Access Audit Site Report

Prepared By
WT Group

Blanco State Park
101 Park Rd 23
Blanco, TX 78606
Accessibility Evaluation
Inspection Date: 02/09/2022
Inspectors: Tanya Scheibe

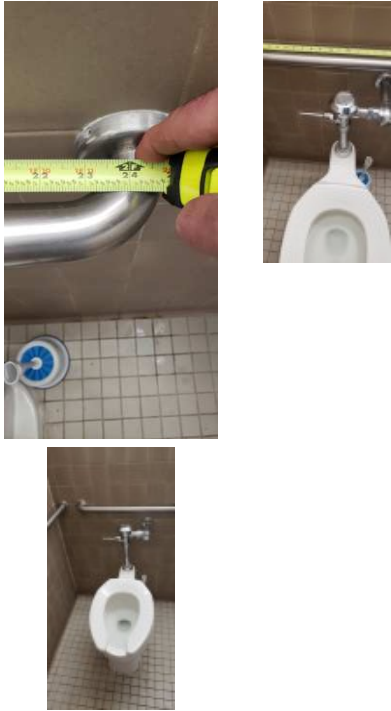
Finding Number	Area Description	Lat/Long	Finding	As Built	Recommendation	Citation	Photos	Figure
23	Headquarters (HQ) : HQ - Men's Restroom	[30.0930765 , -98.423877 8]	The water and drain pipes under the lavatory are not adequately insulated. Water supply and drain pipes under lavatories and sinks shall be insulated or otherwise configured to protect against contact. There shall be no sharp or abrasive surfaces under lavatories and sinks.	Sink lacks insulated pipes	Insulate exposed pipes under one sink.	2015 ABAAS Section: 606.5 2012 TAS Section: 606.5 2010 ADAS Section: 606.5		
24	Headquarters (HQ) : HQ - Men's Restroom	[30.0930869 , -98.423876 5]	The required 56 inches by 60 inches clear floor space for the water closet has been obstructed. The clear floor space around the water closet shall be 60 inches minimum measured perpendicular from the side wall and 56 inches minimum measured perpendicular from the rear wall.	Toilet lacks CFS - 42" to sink	Renovate restroom to provide 60" by 56" clearance around the toilet. In the alternative, leave as is citing safe harbor.	2015 ABAAS Section: 604.3. 2012 TAS Section: 604.3.1 2010 ADAS Section: 604.3.1

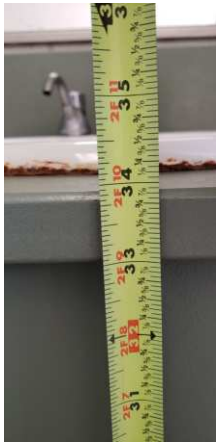
Finding Number	Area Description	Lat/Long	Finding	As Built	Recommendation	Citation	Photos	Figure
39	Day Use : Day Use - Parking	[30.0943238 , -98.421359 2]	Element meets all standards and requirements	Day use area restroom parking (HQ side of river) - meets scoping requirements - 8 standard, 1 accessible	None	2010 ADAS Section: N/A		
40	Day Use : Day Use - Parking	[30.0943517 , -98.421386]	The access aisle is not located on an accessible route of travel to the accessible building entrance. Accessible parking spaces serving a particular building shall be located on the shortest accessible route of travel from adjacent parking to an accessible entrance. In buildings with multiple accessible entrances with adjacent parking, accessible parking spaces shall be dispersed and located closest to the accessible entrances.	Day use area restroom parking (HQ side of river) - route from parking to restroom is through vehicular way	Reconfigure accessible stalls to avoid requiring pedestrians to cross vehicular way, in the alternative, leave as is with striped crosswalk.	2015 ABAAS Section: F208.3.1 2012 TAS Section: 208.3.1 2010 ADAS Section: 208.3.1

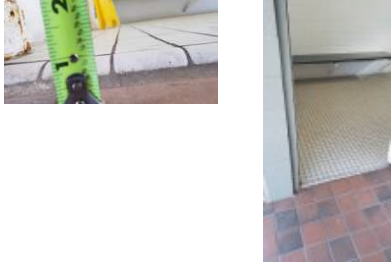
Finding Number	Area Description	Lat/Long	Finding	As Built	Recommendation	Citation	Photos	Figure
70	Day Use : Day Use - West Side Restroom Exterior Accessible Route	[30.0912826 , -98.429527 9]	Stairways must have handrails on both sides. Handrails and their extensions must be between 34 inches and 38 inches above the stair nosing or ground. The top handrails shall extend a minimum of 12 inches beyond the top nosing and shall be parallel with the floor or ground surface. At the bottom of a stair flight, handrails shall extend at the slope of the stair flight for a horizontal distance at least equal to one tread depth beyond the last riser nosing. Extension shall return to a wall, guard, or the landing surface, or shall be continuous to the handrail of an adjacent stair flight. The orientation of at least one handrail, including the extension, shall be in the direction of the run of the stair and perpendicular to the direction of the stair nosing. Handrail gripping surfaces with a circular cross section shall have an outside diameter of 1-1/4 inches minimum and 2 inches maximum. Handrail gripping surfaces with a non-circular cross section shall have a perimeter dimension of 4 inches minimum and 6 1/4 inches maximum, and a cross-section dimension of 2-1/4 inches maximum. The hand grip portion of handrails shall have a smooth surface with no sharp corners. Gripping surfaces (top or sides) shall be uninterrupted by newel posts, other construction elements or obstructions. Any wall or other surface adjacent to the handrail shall be free of sharp or abrasive elements. Handrails projecting from a wall shall have a space of 1-1/2 inches minimum between the wall and the handrail.	Campground side, day use restroom building stairs - Handrail on one side only	Install handrails on both sides of stairway, mounted 34" to 38" AFF with top and bottom extensions and having a 1.25" – 2" in diameter, or a non-circular grip that has a perimeter dimension of 4"- 6.25" max with a min gap of 1.5" between handrail and wall.	2015 ABAAS Section: 505.2 2012 TAS Section: 505.2 2010 ADAS Section: 505.2

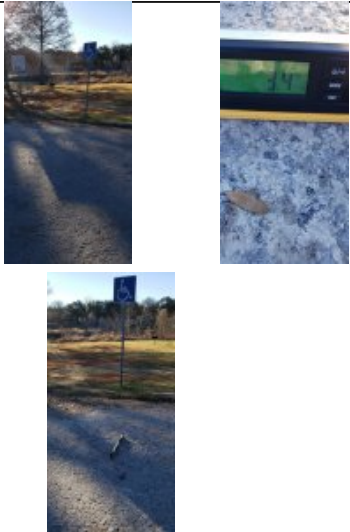
Finding Number	Area Description	Lat/Long	Finding	As Built	Recommendation	Citation	Photos	Figure
79	Day Use : Day Use - West Side Men's Restroom	[30.091264, -98.429568 1]	The grab bar height and/or spacing fails. Grab bars must be mounted between 33" and 36" to the top of the gripping surface. There must be 1.5" of clearance between the grab bar and the wall. There must be a minimum of 1.5" of clearance below and minimum 12" above the grab bar to any dispenser or other obstruction.	Toilet paper 6" above grab bar	Remount toilet paper dispenser max 7" to 9" from front of toilet, 15" to 48" above the finished floor (AFF) and min 12" above or 1.5" below grab bar.	2015 ABAAS Section: 609.3, 609.4 2012 TAS Section: 609.4, 609.3 2010 ADAS Section: 609.3, 609.4		
80	Day Use : Day Use - West Side Men's Restroom	[30.0912559, -98.429576 2]	The toilet paper is not installed within the compliant range in front of the toilet. Toilet paper dispensers shall be 7 inches minimum and 9 inches maximum in front of the water closet measured to the centerline of the dispenser. The outlet of the dispenser shall be 15 inches minimum and 48 inches maximum above the finish floor and shall not be located behind grab bars. Dispensers shall not be of a type that controls delivery or that does not allow continuous paper flow. There shall be a clearance of 1 1/2 inches minimum below the grab bar.	TP dispenser 13" from front of toilet	Remount toilet paper dispenser max 7" to 9" from front of toilet, 15" to 48" AFF and min 12" above or 1.5" below grab bar.	2015 ABAAS Section: 604.7 2012 TAS Section: 604.7 2010 ADAS Section: 604.7

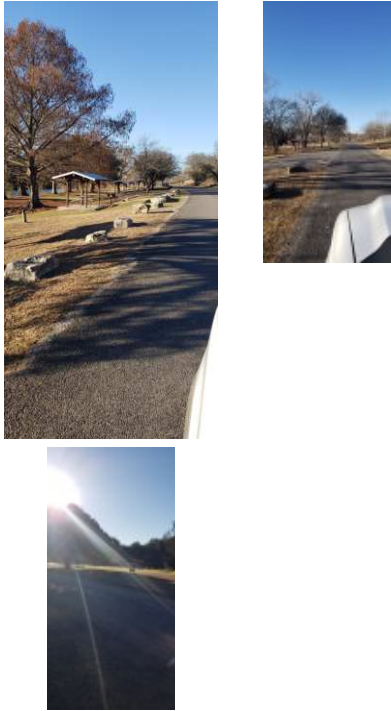
Finding Number	Area Description	Lat/Long	Finding	As Built	Recommendation	Citation	Photos	Figure
81	Day Use : Day Use - West Side Men's Restroom	[30.0912652, -98.4295735]	The accessible route contains running slopes greater than 5 percent and cross slopes greater than 2 percent across the width of the walk and has not been constructed as a ramp (i.e. handrails, wheel guides, etc.). When the slope in the direction of travel of any walk exceeds 1 unit vertical in 20 units horizontal (5-percent slope), it must be constructed as ramp. Surface cross slopes must not exceed one unit vertical in 48 units. Horizontal (2-percent slope).	3.7" cross slope	Correct or repair slope to max 2.08% in restroom.	2015 ABAAS Section: 403.3 2012 TAS Section: 403.3 2010 ADAS Section: 403.3		
82	Day Use : Day Use - West Side Men's Restroom	[30.091257, -98.4295654]	The threshold has a vertical change greater than 1/4 inch high. Exterior doors are recommended to be maintained at 8.5 lbf as a smart practice. Force is to be measured at the operating hardware or 30 inches from the hinges, whichever is greater.	Men's restroom door - 1" change in level (CIL) at door, 10# push	For all doors along the public circulation route, repair, bevel, or ramp CILs at door entries to max .25". For all doors along the public circulation route, inspect, adjust, and maintain 8.5 lbf to open exterior doors as a smart practice.	2010 ADAS Section: 404.2.3, 404.2.7, 404.2.4, 404.2.11, 404.2.11 Exception

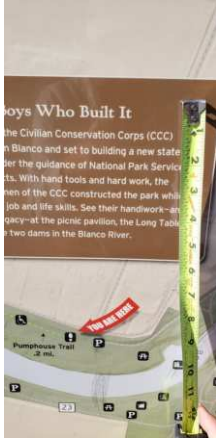
Finding Number	Area Description	Lat/Long	Finding	As Built	Recommendation	Citation	Photos	Figure
89	Day Use : Day Use - West Side Women's Restroom	[30.0912725 , -98.429588 7]	The side grab bars are not in the correct location. Grab bars on the side wall must be installed so that the end closest to the rear wall is maximum 12" from the rear wall. The end furthest from the rear wall must be mounted minimum 54" from the rear wall.	Both bars 52" in length	Replace side grab bar with a 42" long bar mounted to max 12" from the rear wall at the close end and min 54" on the far end, and 33" to 36" AFF.	2015 ABAAS Section: 604.5.1 2012 TAS Section: 604.5.1 2010 ADAS Section: 604.5.1	 	
90	Day Use : Day Use - West Side Women's Restroom	[30.0912652 , -98.429573 5]	The grab bar height and/or spacing fails. Grab bars must be mounted between 33" and 36" to the top of the gripping surface. There must be 1.5" of clearance between the grab bar and the wall. There must be a minimum of 1.5" of clearance below and minimum 12" above the grab bar to any dispenser or other obstruction.	TP 5.5" above grab bar and too close to toilet	Remount toilet paper dispenser max 7" to 9" from front of toilet, 15" to 48" above the finished floor (AFF) and min 12" above or 1.5" below grab bar.	2015 ABAAS Section: 609.3, 609.4 2012 TAS Section: 609.4, 609.3 2010 ADAS Section: 609.3, 609.4

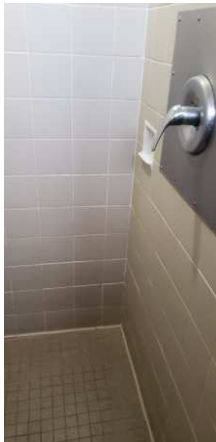
144	Campground Loop: Accessible Shelter - 47	[30.08939, -98.42437]	There is a gap spaced greater than a 1/2 inch. Openings in floor or ground surfaces shall not allow passage of a sphere more than 1/2 inch diameter. Elongated openings shall be placed so that the long dimension is perpendicular to the dominant direction of travel.	1" gap	Correct or fill gaps to be max .5".	2015 ABAAS Section: 302.3 2012 TAS Section: 302.3 2010 ADAS Section: 302.3

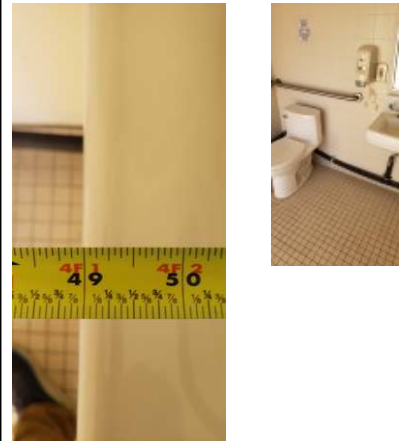
158	Campground Loop: Main Restroom - Men's Restroom	[30.0894921, -98.4243767]	The shower seat height is noncompliant. A seat in a standard roll-in shower compartment shall be a folding type, shall be installed on the side wall adjacent to the controls, and shall extend from the back wall to a point within 3 inches of the compartment entry. A seat in an alternate roll-in type shower compartment shall be a folding type, shall be installed on the front wall opposite the back wall, and shall extend from the adjacent side wall to a point within 3 inches of the compartment entry. The top of the seat shall be 17 inches minimum and 19 inches maximum above the bathroom finish floor.	Shower seat at 20" AFF	Remount shower seat to 17" to 19" AFF in the shower.	2015 ABAAS Section: 610.3 2012 TAS Section: 610.3 2010 ADAS Section: 610.3		 <p>17"-19"</p>

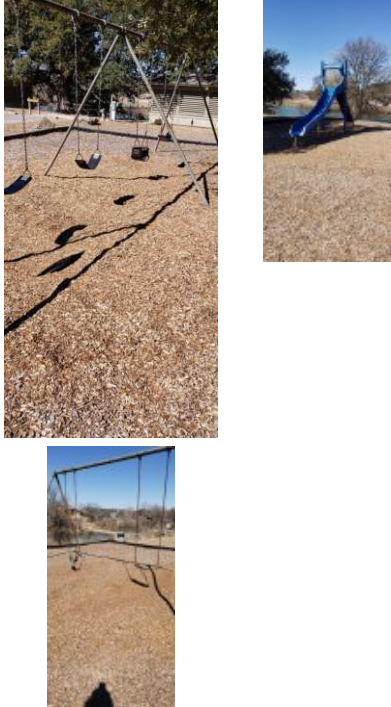
Finding Number	Area Description	Lat/Long	Finding	As Built	Recommendation	Citation	Photos	Figure
170	Campground Loop: Main Restroom - Unisex Bathroom	[30.0894968, -98.4243593]	The side grab bars are not in the correct location. Grab bars on the side wall must be installed so that the end closest to the rear wall is maximum 12" from the rear wall. The end furthest from the rear wall must be mounted minimum 54" from the rear wall.	Side grab bar ends 44.5" from rear wall	Remount side grab bar to max 12" from the rear wall at the close end and min 54" on the far end, and 33" to 36" AFF.	2015 ABAAS Section: 604.5.1 2012 TAS Section: 604.5.1 2010 ADAS Section: 604.5.1	 	
171	Campground Loop: Main Restroom - Unisex Bathroom	[30.0894863, -98.4243767]	The rear grab bar is not 36" long or is not mounted in the correct location. The rear grab bar must be a minimum of 36" long and extend from the toilet centerline a minimum 12" towards the wall side and a minimum 24" towards the open side of the toilet. Grab bars shall be installed in a horizontal position, 33 inches minimum and 36 inches maximum above the finish floor measured to the top of the gripping surface and the space between the grab bar and the top of the tank shall be 1-1/2 inches minimum.	21" from centerline	Remount rear grab bar to behind the toilet, 12" to one side of center and 24" to the other and 33" to 36" AFF.	2015 ABAAS Section: 604.5.2 2012 TAS Section: 604.5.2 2010 ADAS Section: 604.5.2

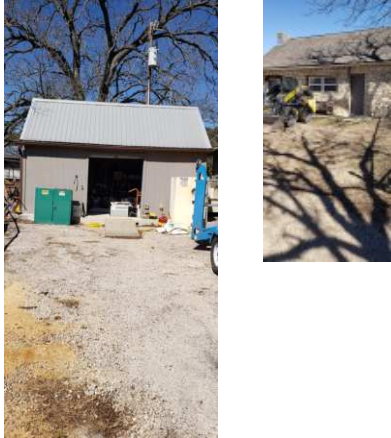
Finding Number	Area Description	Lat/Long	Finding	As Built	Recommendation	Citation	Photos	Figure
180	Park Site: Play Area	[30.089817, -98.4251908]	Compliance with ASTM F 1951 for accessibility for ground surfaces on accessible routes, clear floor or ground spaces, and turning spaces has not been determined. Ground surfaces shall comply with ASTM F 1951. Ground surfaces shall be inspected and maintained regularly and frequently to ensure continued compliance with ASTM F 1951.	Mulch surface for both east and west side play areas	Replace existing surface with an accessible surface such as EWF, PIP or tiles, with compliant slopes and CILs.	2012 TAS Section: 1008.2.6.1 2010 ADAS Section: 1008.2.6.1		
181	Park Site: Play Area	[30.0902348, -98.4244719]	Element meets all standards and requirements	Four swings at east side play area, and 4 swings at west side play area comply if surface and route corrected	None	2010 ADAS Section: N/A

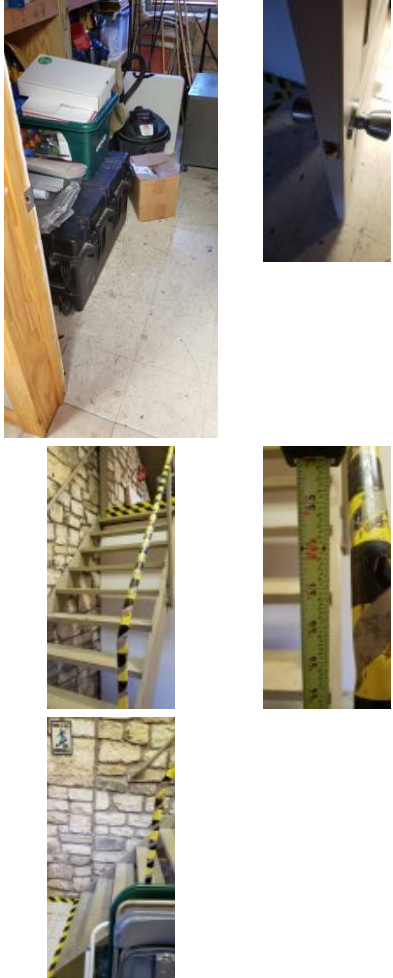
Finding Number	Area Description	Lat/Long	Finding	As Built	Recommendation	Citation	Photos	Figure
188	Park Site: Kayak Boat Launch	[30.0928084 , -98.422775 4]	The parking sign is mounted too low. Parking space identification signs shall include the International Symbol of Accessibility complying with. Signs identifying van parking spaces shall contain the designation "van accessible." Signs shall be 60 inches minimum above the finish floor or ground surface measured to the bottom of the sign.	Bottom edge of parking signs at 48" AGL	Raise existing accessible parking signs so lowest end of bottom sign is min 60" AFF.	2015 ABAAS Section: 502.6 2012 TAS Section: 502.6 2010 ADAS Section: 502.6		
189	Park Site: Kayak Boat Launch	[30.0926123 , -98.422921 6]	The running slope of walking surfaces shall not be steeper than 1:20.	5.9% running slope	Correct running slope along the AR to max 5%.	2015 ABAAS Section: 403.3 2012 TAS Section: 403.3 2010 ADAS Section: 403.3

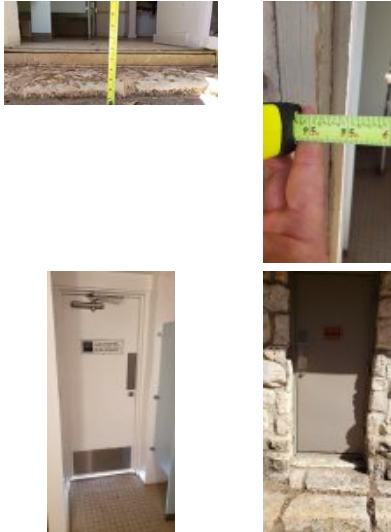
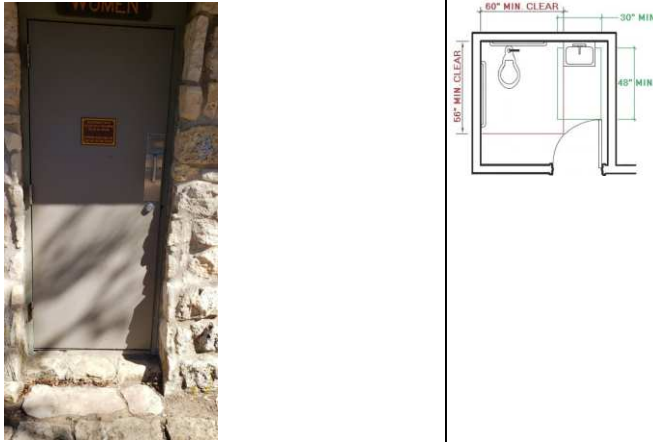
Finding Number	Area Description	Lat/Long	Finding	As Built	Recommendation	Citation	Photos	Figure
203	Park Site: Pavilion	[30.0900212 , -98.424737 5]	The running slope of walking surfaces shall not be steeper than 1:20.	Running slope of 8.6% slope on AR to pavilion, table obstructs landing at top of ramp	Correct running slope along the AR to max 5%. Relocate picnic table to provide unobstructed route of travel to pavilion.	2015 ABAAS Section: 403.3 2012 TAS Section: 403.3 2010 ADAS Section: 403.3
